Upper Thames River Conservation Authority Hearing Committee Meeting Agenda

5. Application #153-24

Proposed Development Activity within a Riverine Flooding Hazard Regulated by UTRCA located at 1310 Adelaide Street North and 795 Windermere Road, City of London

Figure 17: Preferred Alternative – Change in Flow Velocity for the Regulatory Flow Event (1250 cms).

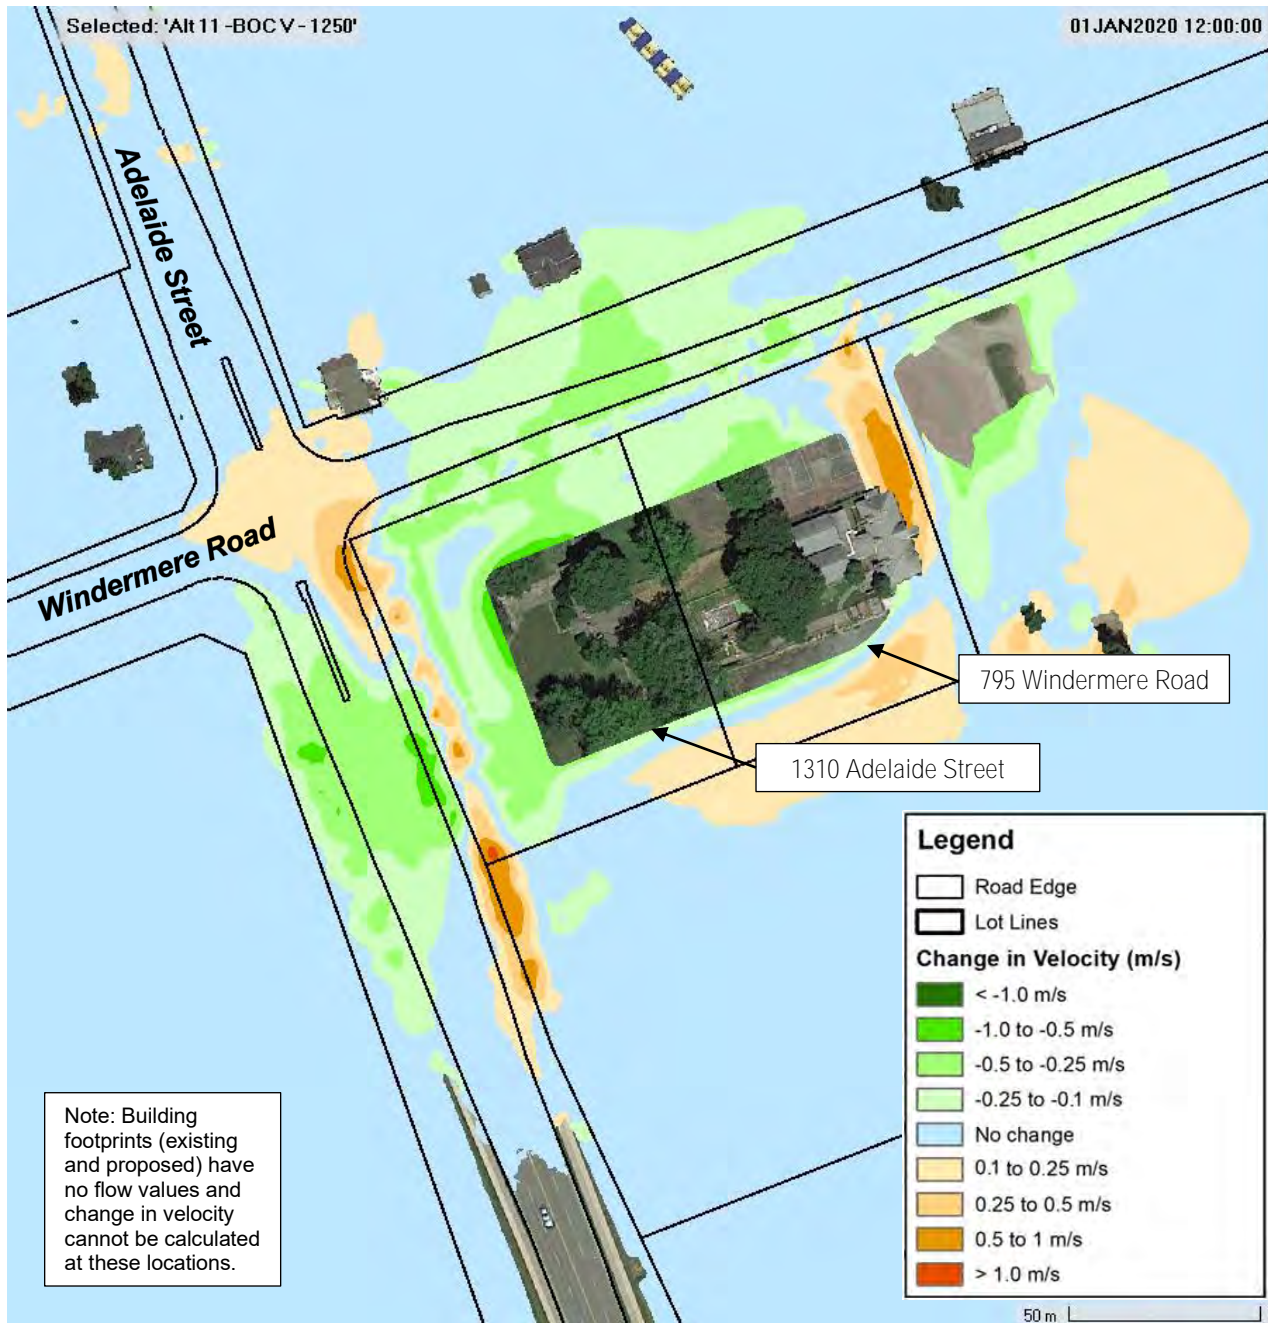
- a. Although the impact assessment suggests that the increase to the adjacent parkland is minimal and considered not a change in risk, the fact remains that the adjacent UTRCA/London property will experience an increase in flood velocities and flood depths resulting from the proposed development and remains a high flood risk area.

The proposed floodproofing of the subject lands will change flow dynamics such that there are both increases and decreases in flow velocity as flood waters move around the floodproofed area. While small areas of increase in velocity are expected to occur, these are offset by areas of decrease in flow velocity, resulting in an overall reduction in flow velocity. This is presented in Figure 17 of the Floodplain Impact Assessment Report.

Figure 18: Preferred Alternative – Change in Velocity Based Flood Risk for the Regulatory Flow Event (1250 cms).

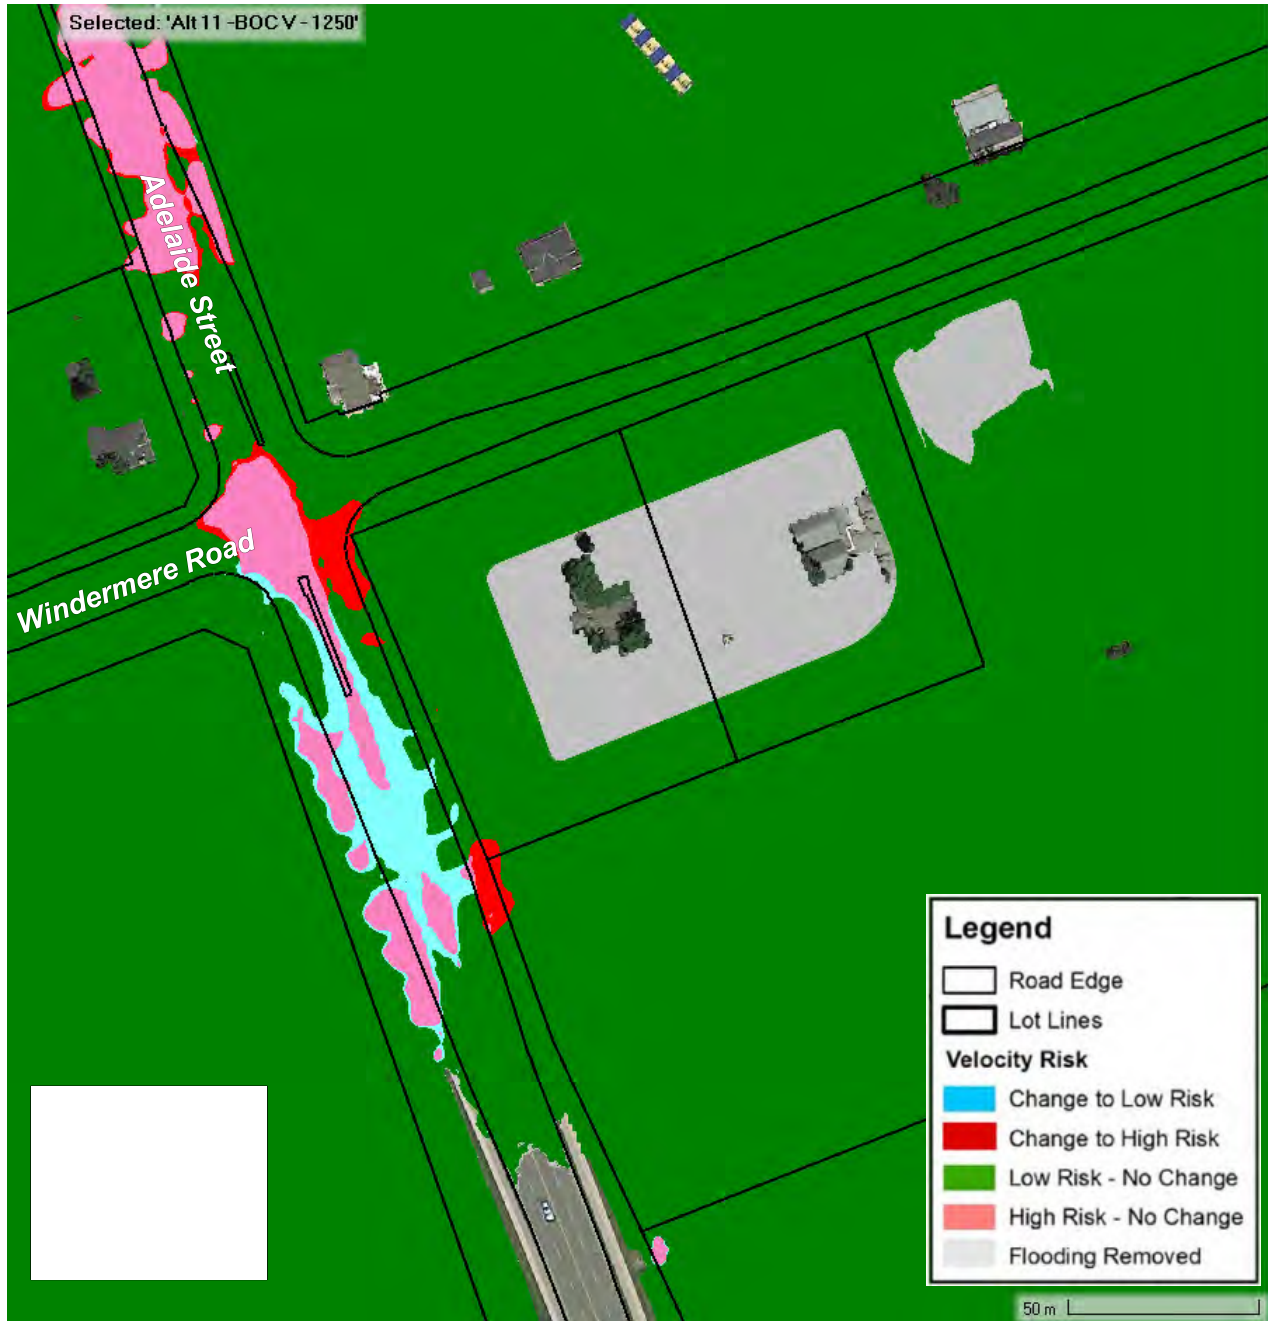
- Adelaide Street: The preferred site layout changes flow conveyance over Adelaide Street during the Regulatory flow event causing a redistribution of velocity-based flood risk along Adelaide Street. Despite this change in the spatial distribution of flood risk, there is no expected net increase in high flood risk and there is no change in the access and egress conditions along Adelaide Street compared to existing conditions.

- Velocity-based risk is low on Adelaide Street, while overall flood risk remains high (depth x velocity > 0.4 m²/s). There is a spatial redistribution of low and high risk areas on Adelaide Street, however, there is no net change in overall flood risk on Adelaide Street compared to existing conditions (refer to Figure 18).
